# Service-Information

Group 34 Brakes	April 1984	Bulletin No.: 34 006 84 (2092)
--------------------	---------------	-----------------------------------

RE: PULSATING REAR DRUM BRAKES

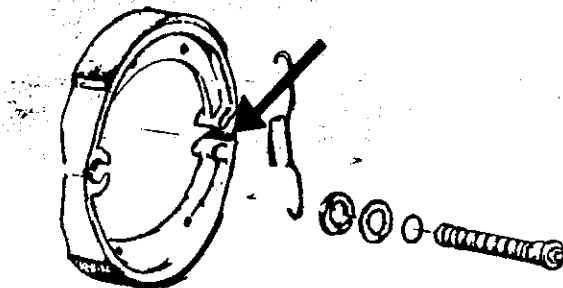
Even after all tolerances of the rear wheel brake drum are met, pulsating of the foot brake pedal can be felt. Generally, this is caused by a slightly uneven contact of the brake shoe and the brake lever cam.

Filing down the contact surface of the lower brake shoe (about 0.1mm where it touches the brake lever cam will improve the pulsating feeling felt by the rider.  
(See drawing below).
